Project Name	BCWD Permit 23-19, Liberty Academy Expansion	Date	October 4, 2024
To / Contact info	BCWD Board of Managers		
Cc / Contact info	Mike Brandt, PE / Kimley-Horn		
Cc / Contact info	Rebekah Hagstrom / Liberty Classical Academy		
Cc / Contact info	Karen Kill, Administrator / BCWD		
From / Contact info	Ryan Fleming, PE; Paul Nation, PE; John Sarafolean / EOR		
Regarding	Permit Application No. 23-19 Engineer's Report

Liberty Classical Academy is requesting approval of both a regional stormwater-management plan and a permit for specific land-disturbing activities at its existing site, 10158 122nd Street North in Hugo. The currently proposed work involves expanding the school campus to the east into May Township. Hugo & May Township are each requiring a conditional use permit for the proposed project. The property includes three parcels owned by Liberty Classical Academy, totaling 82.6 acres. The site is bordered by Keller Avenue North on the west, by 122nd Street North on the south, by Goggins Lake on the east, and by farmsteads to the north. Under current conditions, there are 7.4 acres of impervious coverage on the site. This includes the existing school building, playground

Figure 1: Full site buildout plan and stormwater management features.

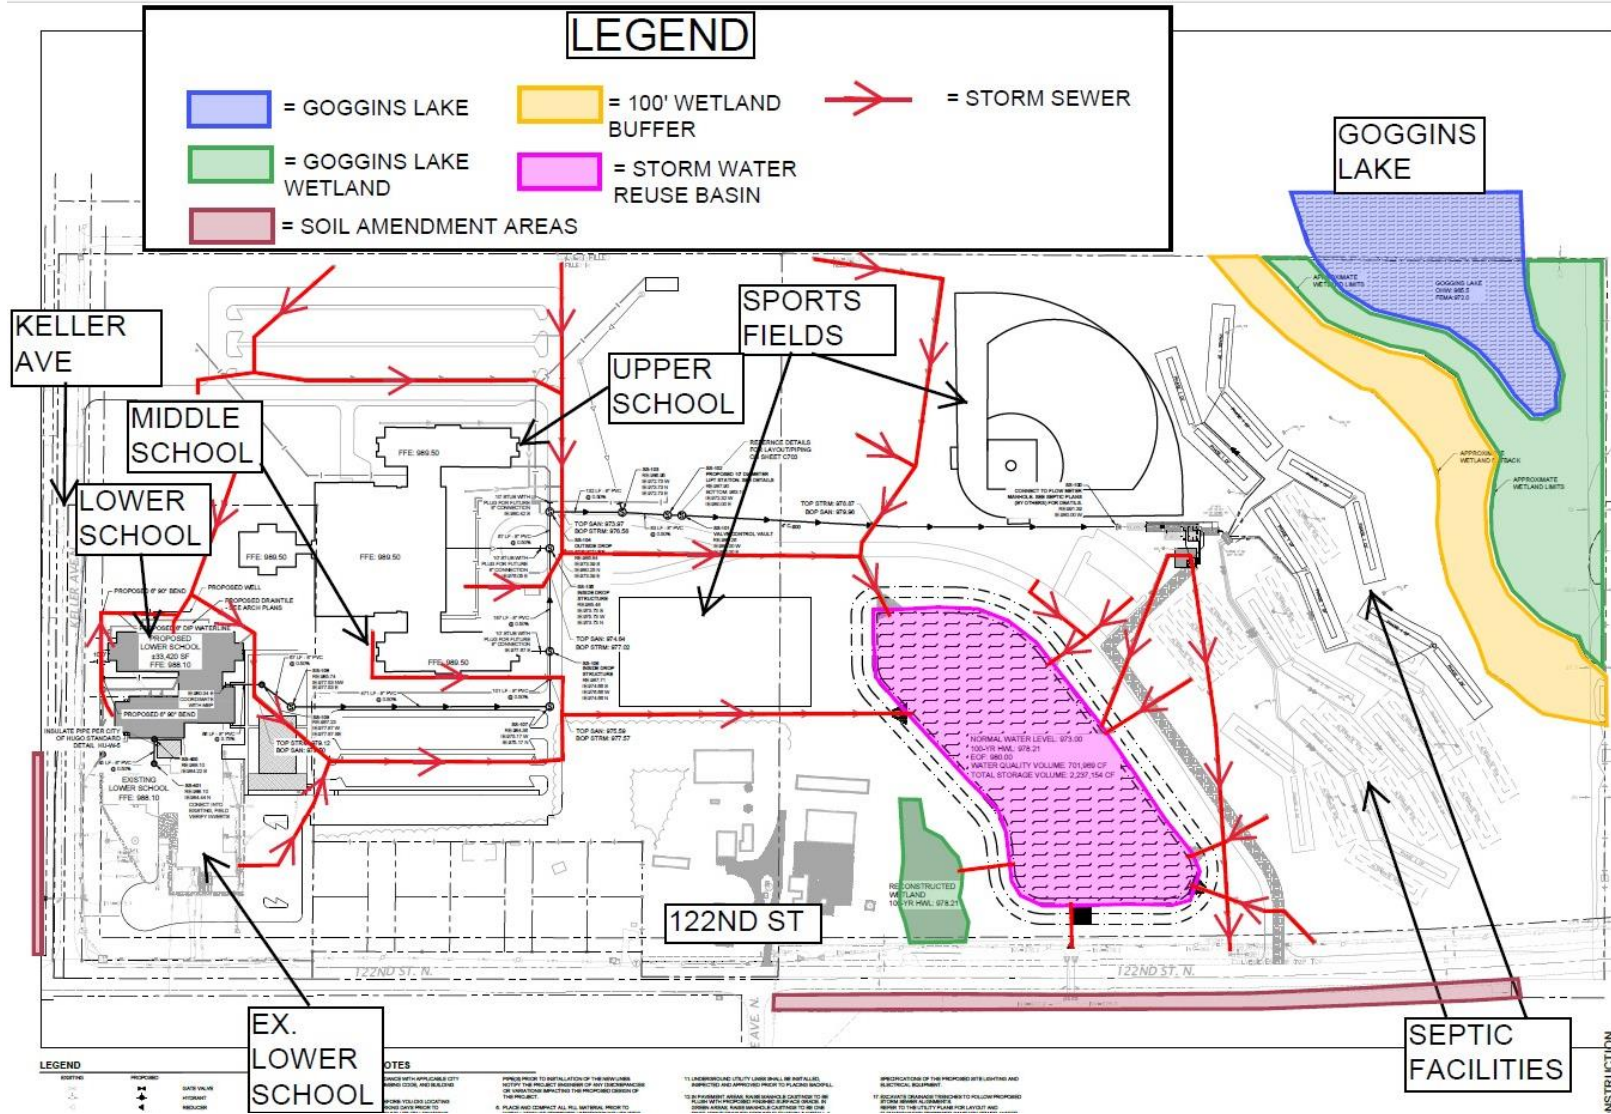
The applicant requests approval of a regional treatment plan pursuant to section 2.9 to provide treatment for the currently proposed and future redevelopment of the site. The proposed drainage areas are shown in Figure 3 and the stormwater facilities proposed under the regional treatment plan are shown in Figure 1.

Figure 2: Existing site drainage.

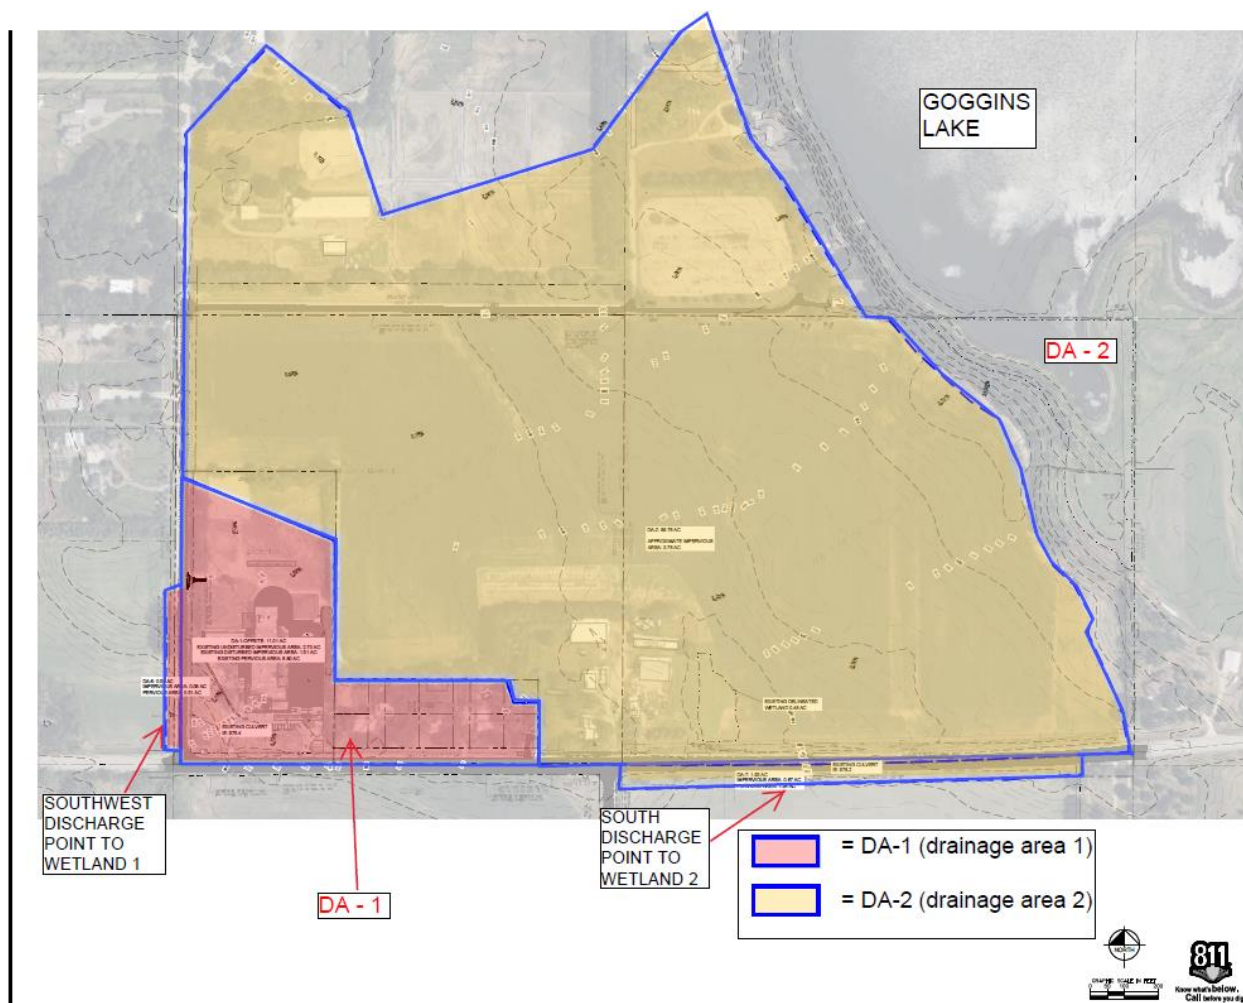
As shown in Figure 2, there are currently two discharge points from the site:

- *The southwest discharge point is located at the property boundary to the west of Keller Avenue where the ditch drains off Liberty Classical property. There are 11.6 acres draining to this location, including three offsite residential lots and the ditch adjacent to Keller Avenue. Stormwater discharges from this location to the south through a culvert under 122nd Street into offsite Wetland 1 south of the site, then travels east to a second offsite wetland (Wetland 2), and continuing west to the BCWD Trout Habitat Preservation Project (THPP).*
- *The south discharge point is located south of the Liberty Classical property boundary where two culverts discharge beneath 122nd Street. There are 90.7 acres draining to this location that includes privately owned farmsteads to the north, an onsite residential property, a 0.48-acre*

onsite wetland, and the ditch adjacent to 122nd Street. After crossing beneath 122nd Street, runoff flows overland to Wetland 2, then to the THPP.

Figure 3: Proposed site drainage.

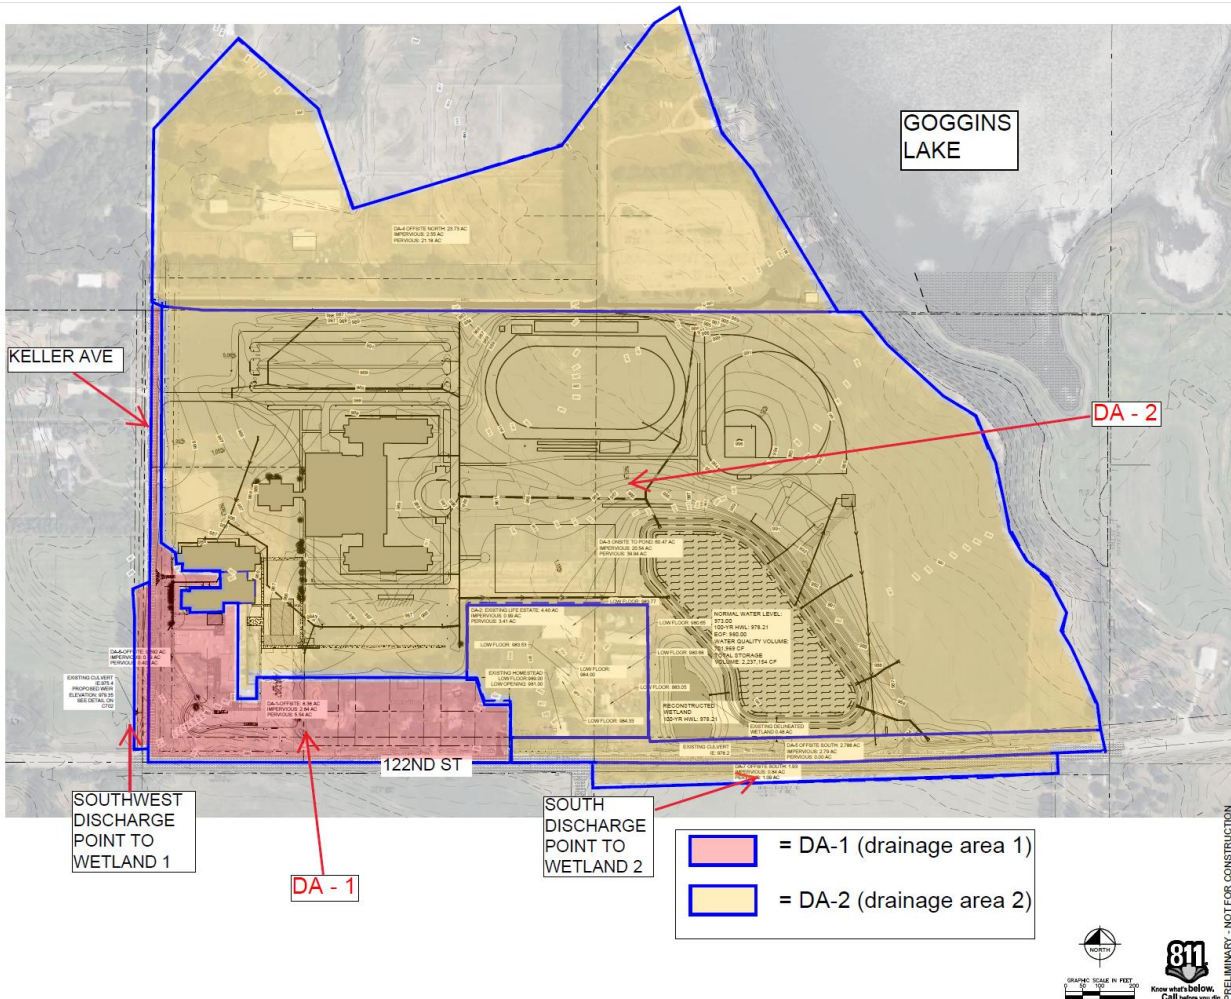
Phase 1 activities will drain to both the southwest and south discharge points. Planned grading will shift the drainage areas, directing less area to the southwest discharge point, and more area to the stormwater treatment basin that discharges to the south discharge point as described in the regional treatment plan analysis above and shown in Figure 2 and Figure 3.

Figure 4: Phase 1 proposed construction.

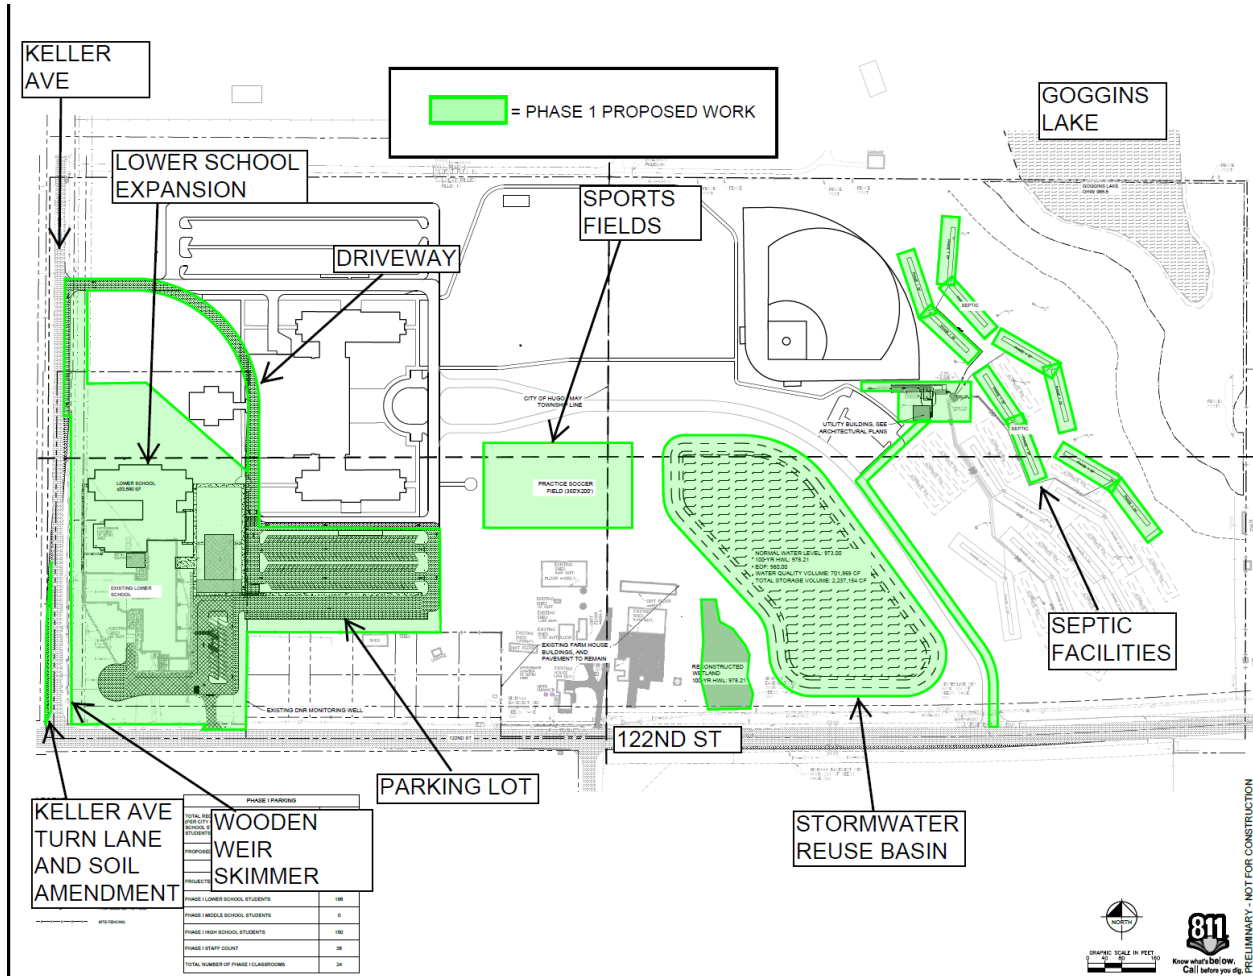
In conjunction with the request for approval of the regional plan, Liberty Academy is requesting approval of a permit for an expansion project that will utilize a portion of the capacity of the regional stormwater-management system to meet applicable BCWD requirements. Phase 1 includes a new lower school building, a parking lot, a practice soccer field, the septic sewer system for phase 1, a turn lane on Keller Avenue, and a stormwater basin (Figure 4).
